From:	Lyons, John
To:	Wetmore, Cynthia
Cc:	Barton, Dana
Subject:	RE: pCBSA Impact and Lynnwood - follow-up
Date:	Wednesday, January 07, 2015 7:54:00 AM
Attachments:	image001.png image002.png image003.png

From: Wetmore, Cynthia
Sent: Thursday, December 18, 2014 10:44 AM
To: Lyons, John
Cc: Barton, Dana
Subject: pCBSA Impact and Lynnwood - follow-up

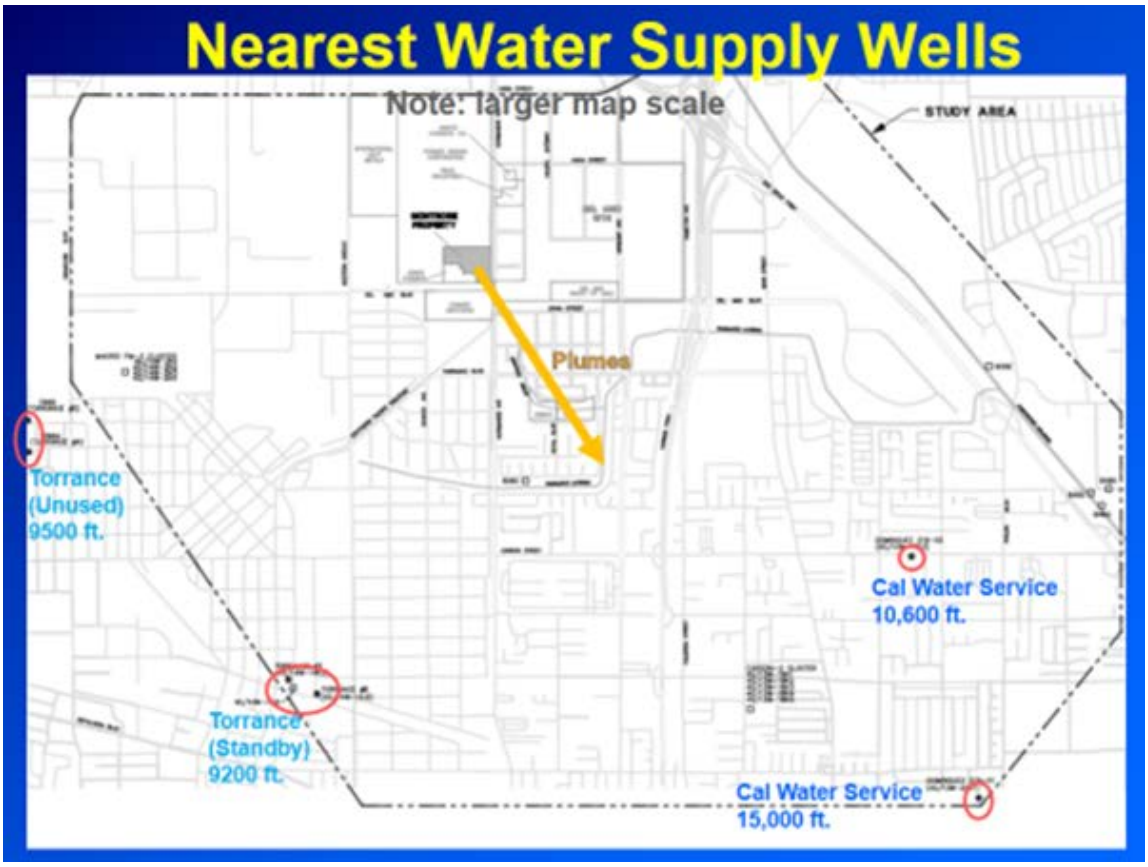
Natasha – is this map show the distance from the Montrose Site to nearest supply well (or distance from edge of plume to supply wells) thanks, Cynthia

Hi Cynthia,
Based on our analysis, it doesn't appear that any of the nearby production wells will be impacted by pCBSA within at least 26 years. This is because:
(1) the pCBSA plume from the injection occurring west of the Montrose site appears to be contained by Mobil remediation wells and doesn't travel further to the west, and
(2) there are no production wells within at least 2 miles of the Montrose site to the east. Based on the limited data available for the Lynwood aquifer beneath the dual site, the flow direction in

the Lynwood aquifer is to the east. An approximate rate of plume migration in the Lynwood aquifer estimated using the model appears to be 400 ft per year. Based on the above, it will take more than 26 years for the plume to travel 2 miles to the east. Given the fact that production wells are located further than 2 miles from the site to the east, these wells will not likely be impacted by the pCBSA plume from the eastern injection wells for at least 26 years.
